Denial Memorandum

PRELIMINARY/FINAL MAJOR SITE PLAN OF BARNACLE BILL'S RESTAURANT

PRELIMINARY/FINAL MAJOR SITE PLAN

Re: Barnacle Bills
1 First Street; Block 5, Lot 2, GB Zone
Preliminary & Final Major Site Plan
Completeness Review, Engineering Review, and Fee Determination

TOPOGRAPHICAL SURVEY MAP OF PROPERTY KNOWN AS
LOT 2 IN BLOCK 5

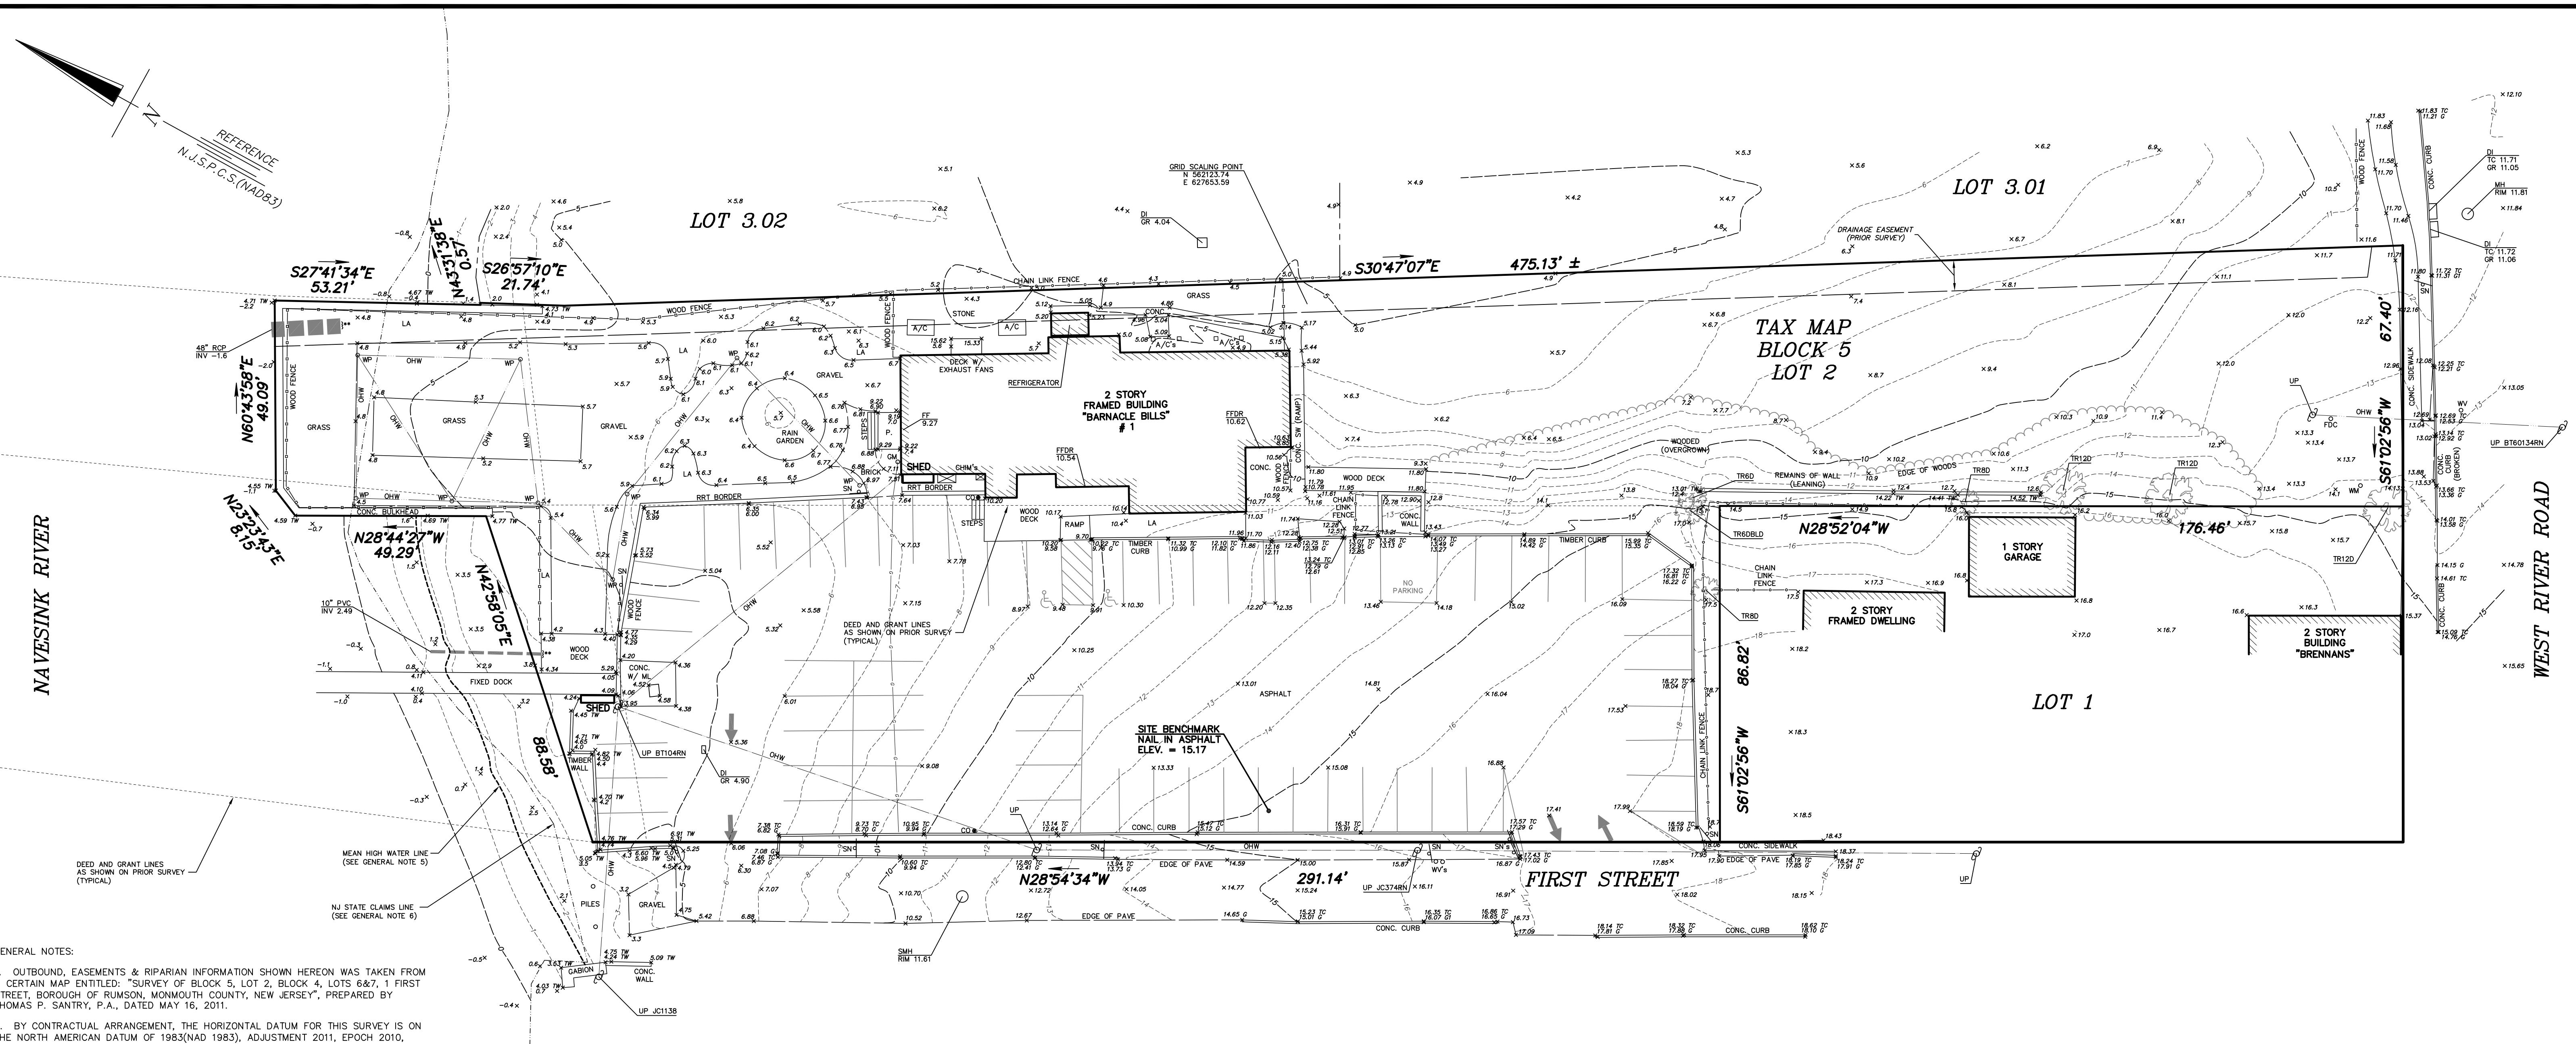
- **Item B12** – Date of current property survey. (*It is noted that the property survey, dated 2022, does not depict the existing outdoor dining area which currently exists on site. I have no objection to the Board granting a completeness waiver for this item.*)

TITLE SHEET

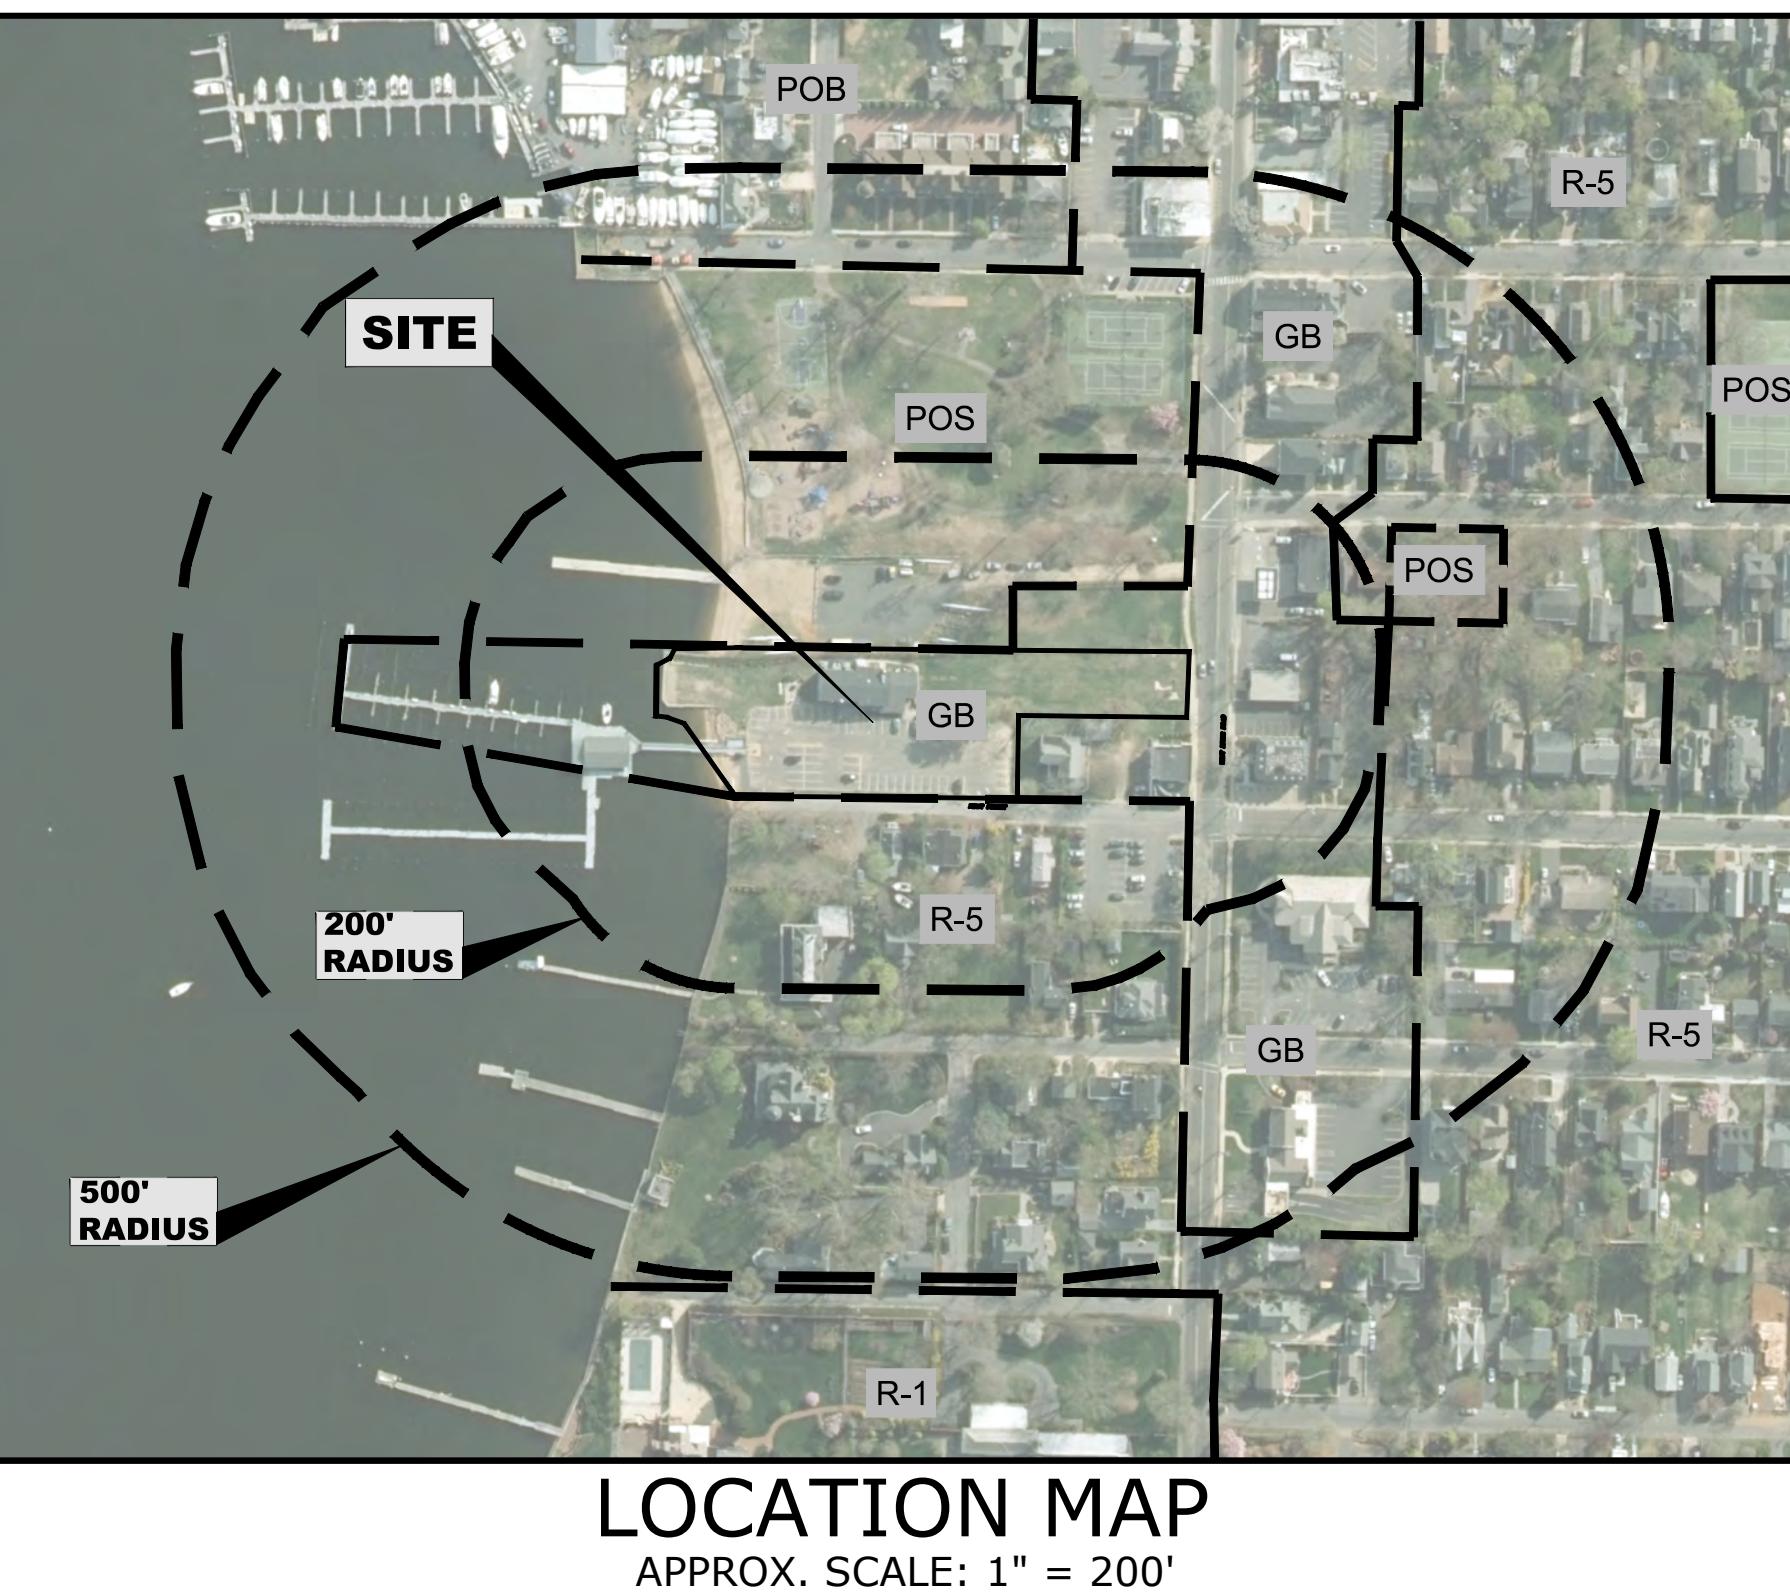
1.2 Per Schedule 9-2 of the Borough Ordinance, the site plans indicate that the proposed outside dining seating expansion as well as the existing restaurant use and marina use requires one hundred and forty-four (144) on-site parking spaces, whereas sixty-one (61) spaces are provided. Therefore, a variance will be required. The site plan should be revised to clarify this as a new variance which is required.

LAYOUT PLAN

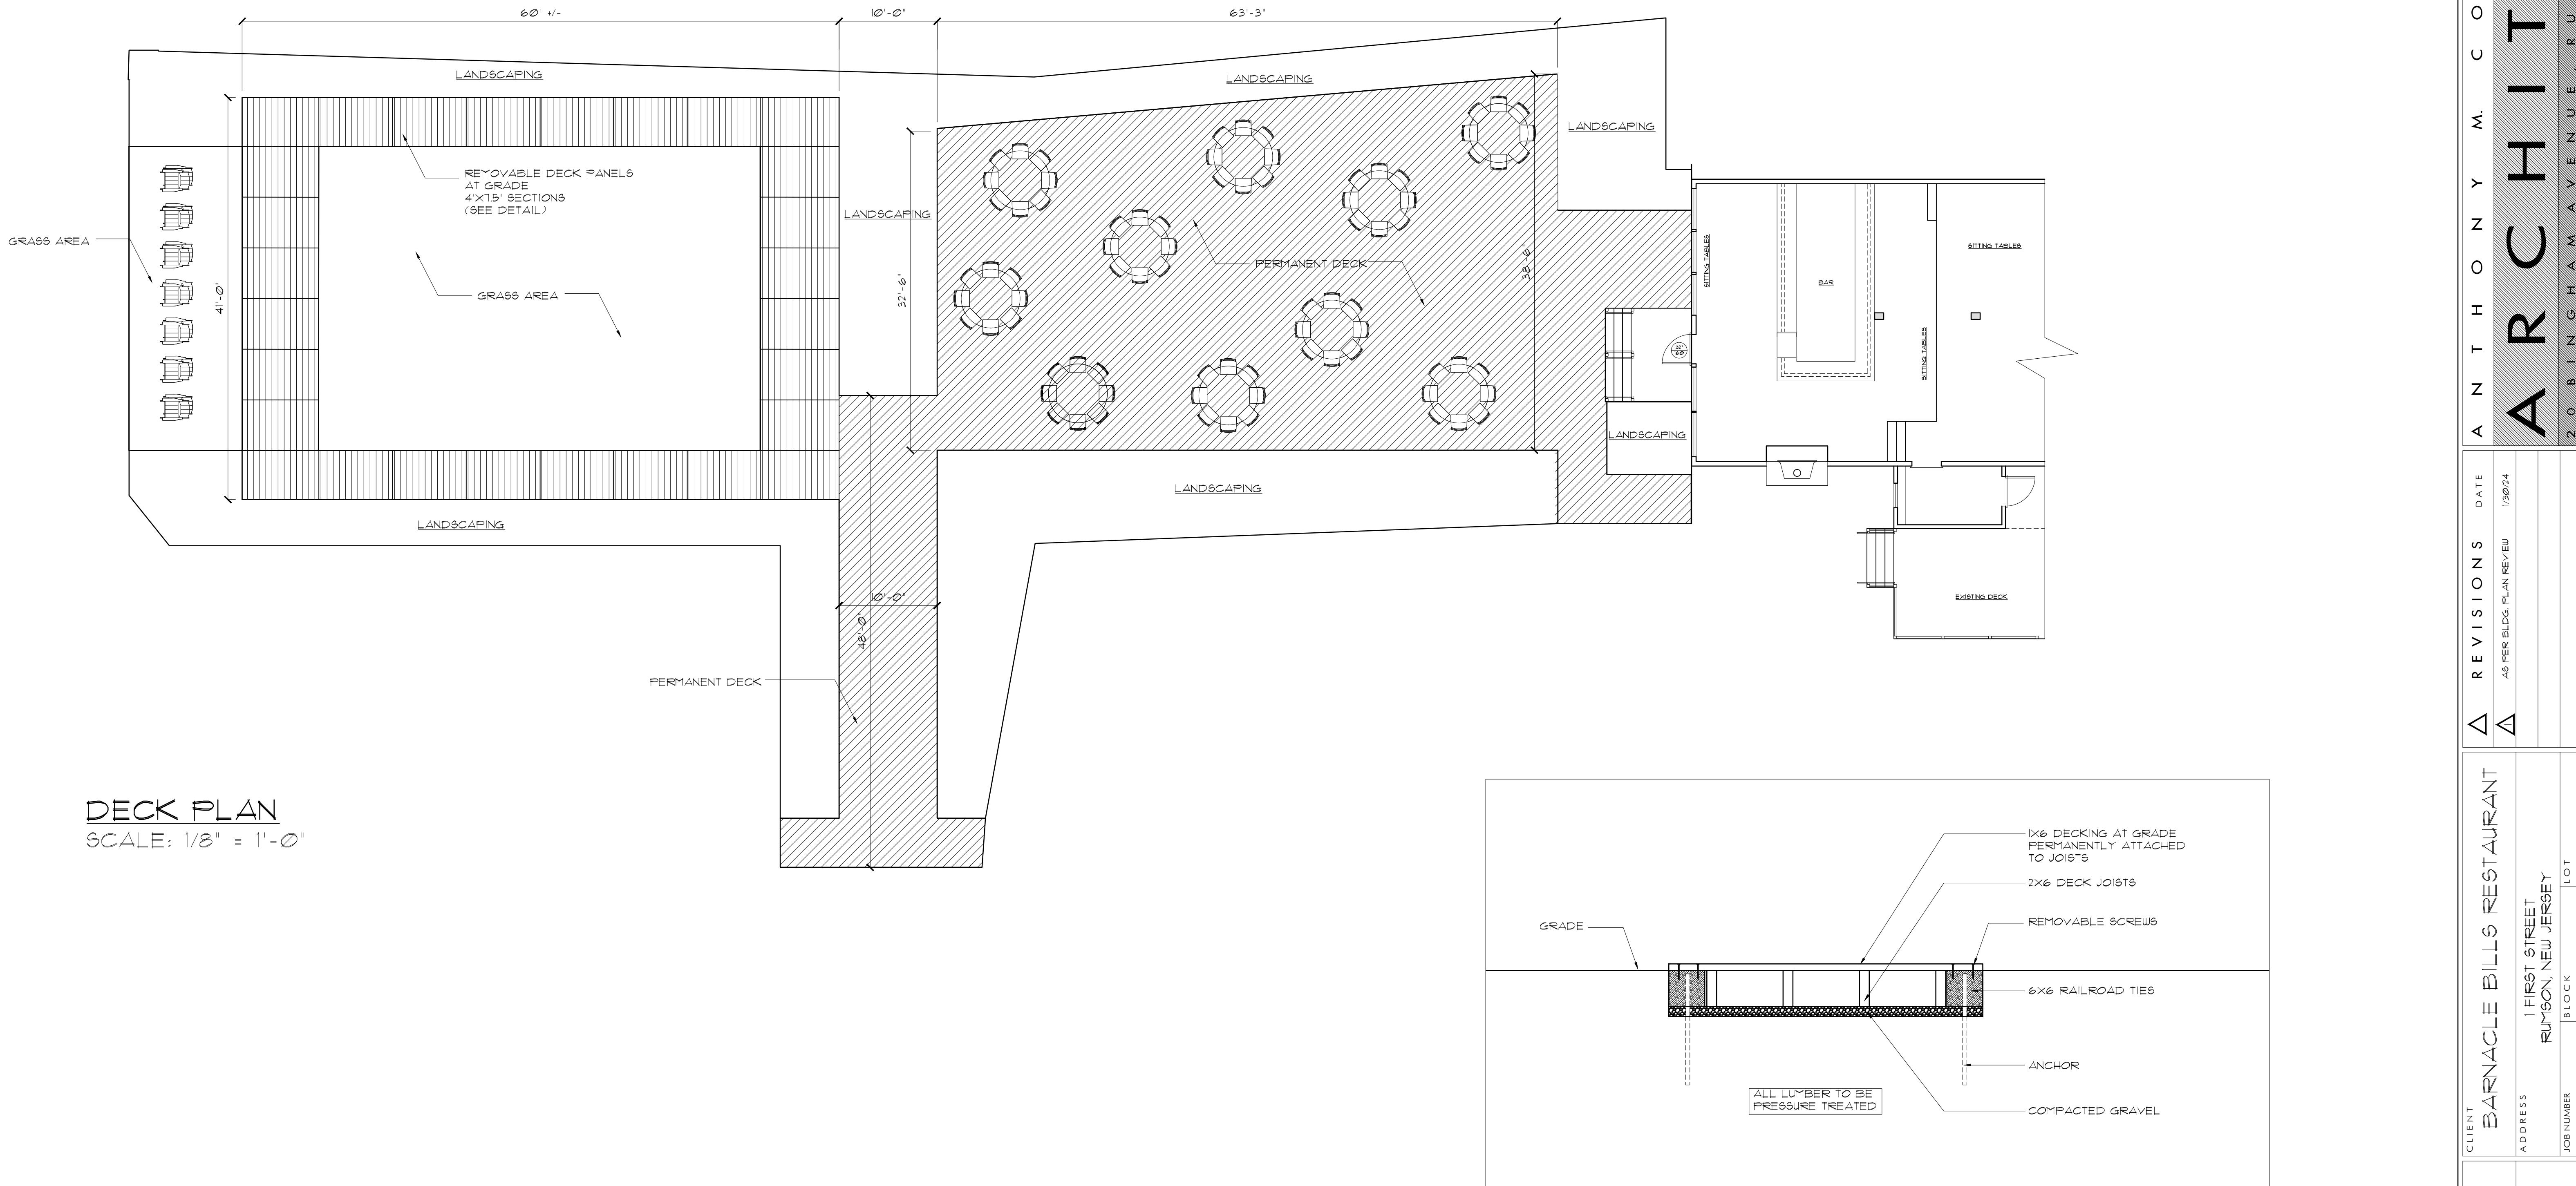
- i. Ordinance §22-7.37.a.2.(1) notes that outdoor cafes not result in any changes from the existing site improvements. The applicant proposes to construct an outdoor seating area and decking.

- ii. Ordinance §22-7.37.a.2.(2) notes that outdoor cafes be located between the restaurant use and the front property/street line on an existing improved surface. The applicant proposes the improvements in the side yard over an existing gravel area.

- iii. Ordinance §22-7.37.a.2.(3) requires that outdoor cafes not result in any additional seating. The applicant proposes forty (40) additional seats within the outdoor café area and does not appear to propose to remove interior seating.

- iv. Ordinance §22-7.37.a.2.(4) requires that outdoor cafes not result in additional lot coverage. The proposed improvements increase the lot coverage by 3,886 square feet.

- v. Ordinance §22-7.37.b requires outdoor cafés to be setback from a lot line by 50% of the required setback as noted in §22-6.10c. Therefore, the outdoor café requires a side/rear setback 17.5 feet. The applicant proposes a setback of 6.1 feet from the rear property line to the outdoor area.

2.1 The Site Plan indicates a maximum of 144 parking spaces are required. 61 existing parking spaces are provided which will not satisfy the Borough's parking requirements of Ordinance §22-9.2b.1.(c), Exhibit 9-2. A variance is required. A parking calculation shall be provided to confirm how the parking requirement was determined.

2.2 The applicant shall confirm that an ADA accessible route will be provided from the parking lot to the outdoor dining area.

2.3 The applicant should clarify if any lighting is proposed or if existing lighting will be sufficient for the outdoor areas.

3.2 The applicant should ensure any landscaping proposed within the existing drainage easement area doesn't include larger trees to avoid conflicts with the existing 48" RCP drainage pipe.
